Capacity Performance

Education and Dialogue Session
August 12, 2014

Figure 5: Forced Outages

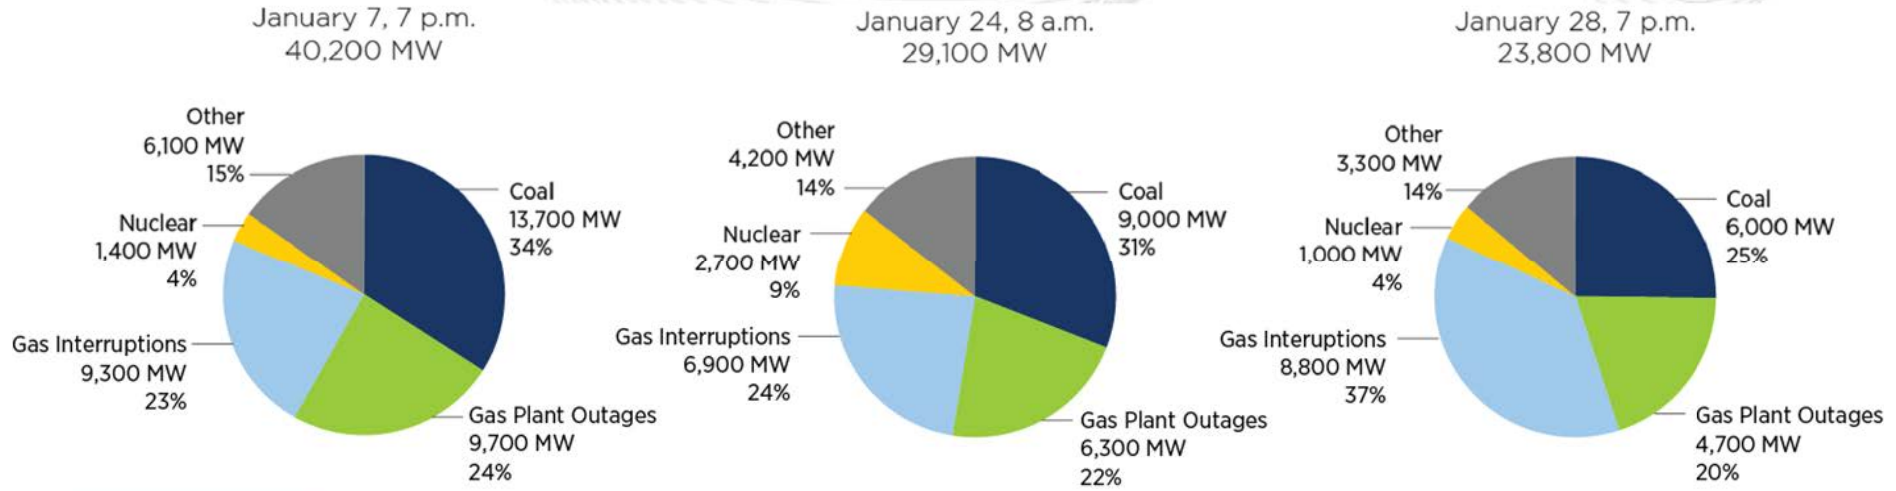
- 13,700 MW coal out on January 7 with 13,000 out because they had no natural gas to start. Why weren't these units already on?
- Figure 5 is confusing. Pie charts have different days than table and are not in chronological order, or is the middle chart supposed to be January 24?

Loss of Load Probability on Peak Winter Day

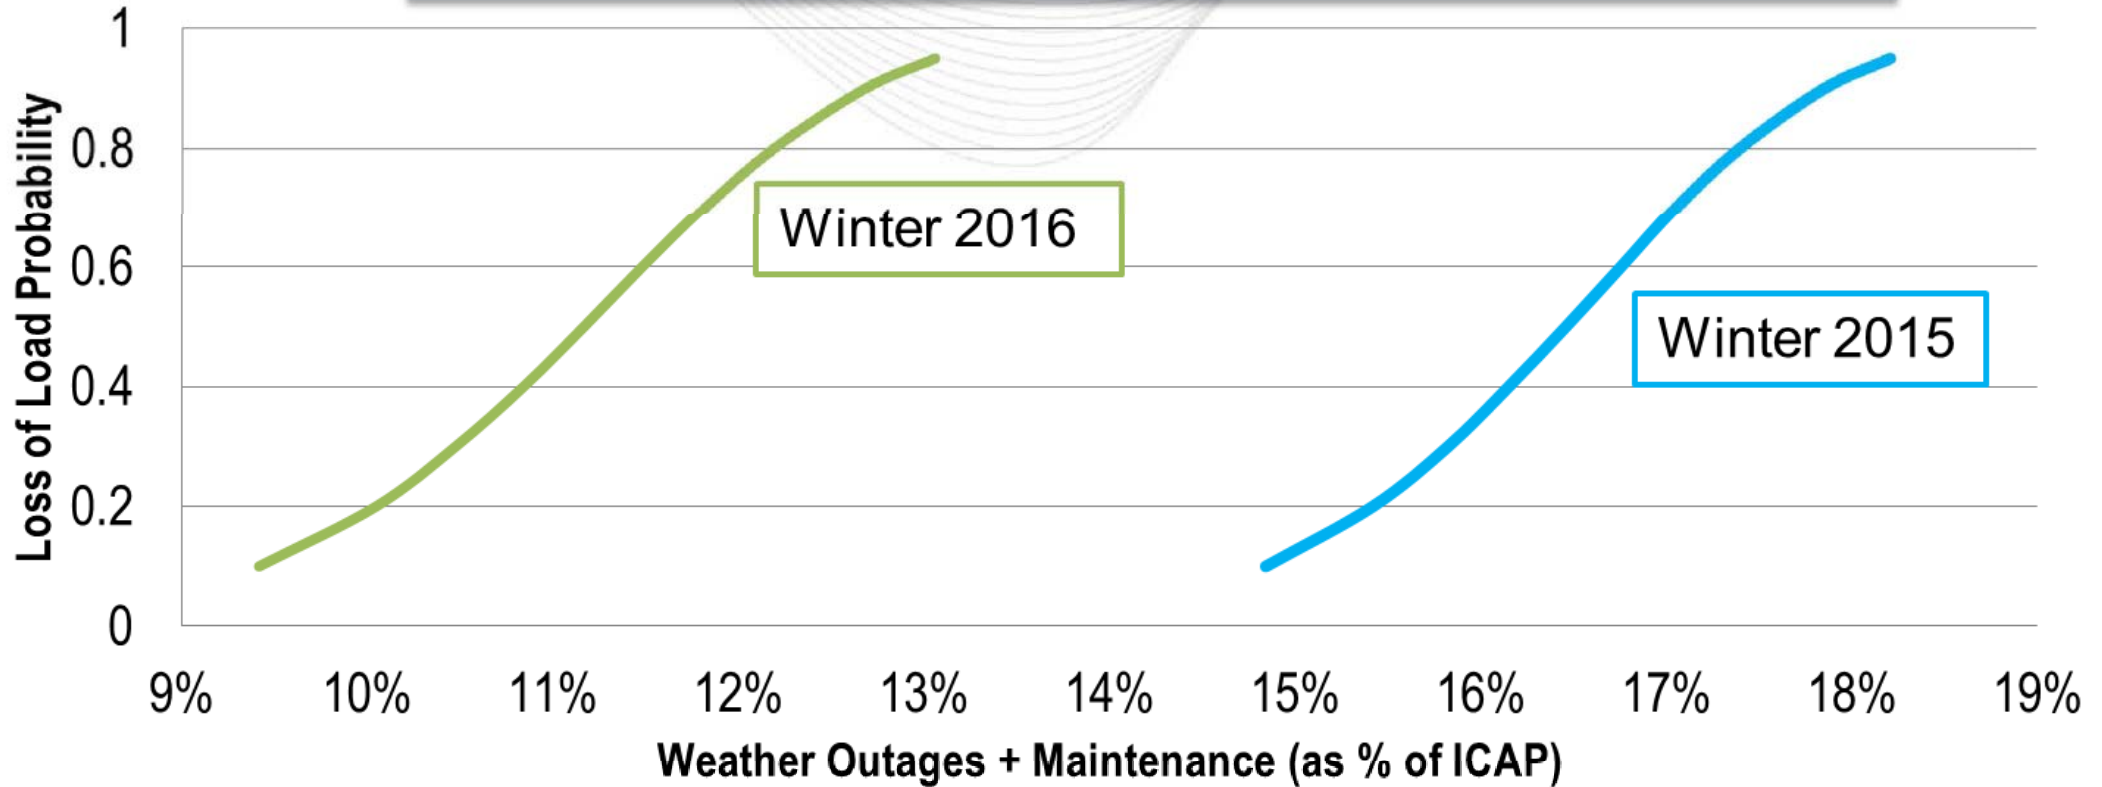
- What is Short-term spot firm transportation?
- LOLP (Should we consider an LSE's peak load obligations as well)
- Need more explanation of unnumbered figure (7?) on page 16 and discussion on how a 15% outage rate in winter translates to a 10% LOLP
- Are figures 7, 8 and 9 all based on the PJM LOLP study? How do these figures tie together?
- "Performance data from January, 2014, clearly indicate that, under extreme winter conditions, the amount of unavailable generation can exceed 20 percent of the total generation fleet." But is it usual to expect that high a level of outages? Thought this was unusual. During "normal" weather, outages much less. So do we plan for LOLP based on extreme or normal?
- Perhaps I read too quickly, but the only thing I saw that made me think about redefining capacity was the "lack of compensation for resource flexibility."
